# La Jolla Shores Planned District Advisory Board (LJSPDAB) APPLICANT PROJECT INFORMATION FORM

- PRJ # 705977 Coppel Residence Remodel & Addition + ADU
- Address and APN(s):
- 7856 La Jolla Vista Drive, La Jolla, CA 92037, APN 346-742-11-00
- Project contact name, phone, e-mail:
- Michael R. Morton AIA, (619) 857-8144, Michael@m2a.io
- Project description:
- Renovation of existing single-story single-family residence of 3,659 Square Feet (Main House)Addition and remodel to existing single-story single-family residence with 1,765 square feet to be demolished with and addition of 2,439 square feet. New detached ADU of 514 square feet. With a total addition of 625 detached garage square feet + 515 ADU = remodel area of 1,118 square feet. The proposed remodeled home to total 4,848+ 625 detached accessory garage = 5,473 square feet Total

Project Nbr: 705977 Title: Dig Prelim 7856 LJ Vista Dr

Project No. **PTS-0705977** – 7856 La Jolla Vista Drive, La Jolla, CA 92037

**LOT RADIUS WITHIN 300 FEET**

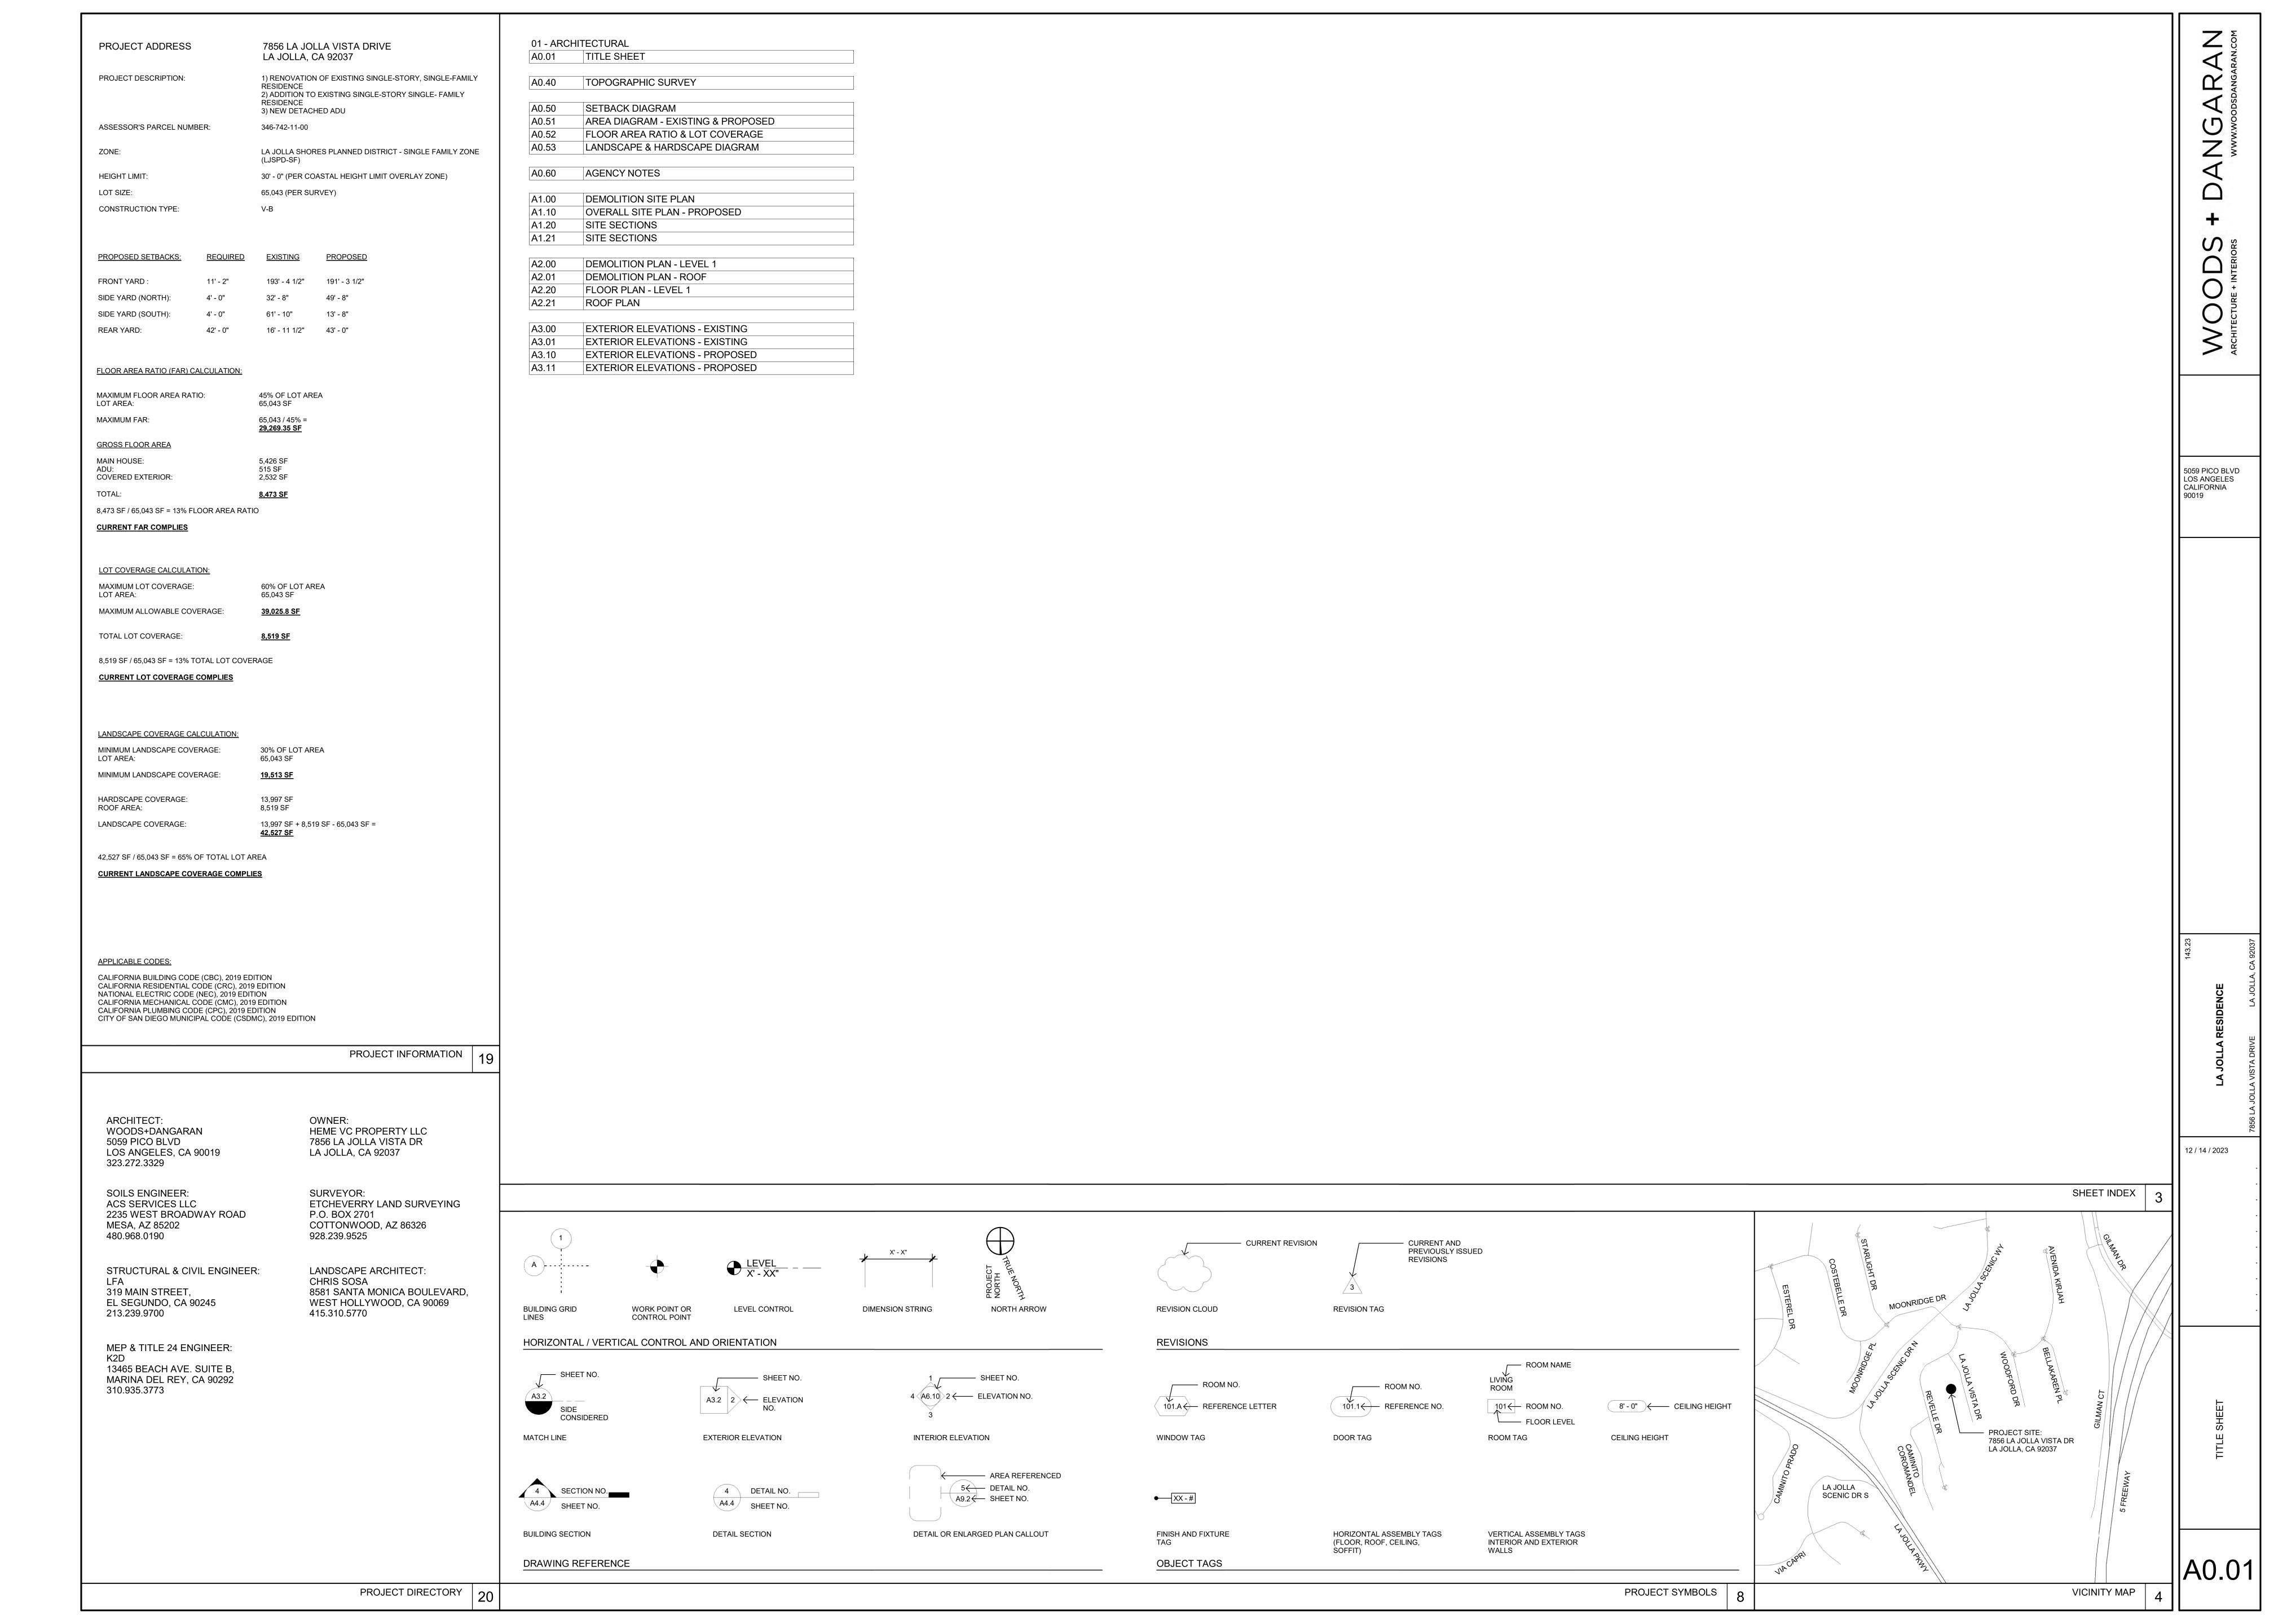
Staff have received resources in the form of a 300-foot radius map prepared by consultants to determine the general conformity of the vicinity. The resources provided can vary but must provide an accurate map that is to scale, along with a list of the properties, and setback analysis. Staff will not recommend the approval of any structure that is different in quality, form, materials, color, and relationship as to disrupt the architectural unity of the area. (From Cycle 1)

In accordance with section 1510.0304(b)(1), buildings with openings that face the side property line shall be constructed no closer than 4-feet from the property line. In addition, a 300-foot radius map will be used by staff to determine the general conformity with those in the vicinity. The resources provided may vary in form as long as it provides an accurate map that is to scale, list the properties within a 300-foot radius and contains the setback analysis. Staff will not recommend the approval of any structure that does not comply with those in the community. (From Cycle 1)

The setbacks for the subject property will be determined based on the neighboring properties that fall within the 300-foot radius. A 300-foot radius map is required that encompasses the address, legal description, lot size, and all required yards in a tabular form for all properties within the 300-foot radius. (From Cycle 1)

A-005) We will provide an updated 300' radius map to scale with updated list of properties with analysis on front, side & rear setbacks to show project conformance to LJPDO provision.

A-006) Comment noted. See revised 300' setback survey on sheet A0.50. (Attached)

A-011) Acknowledged. Please see the 300' radius survey on sheet A0.50
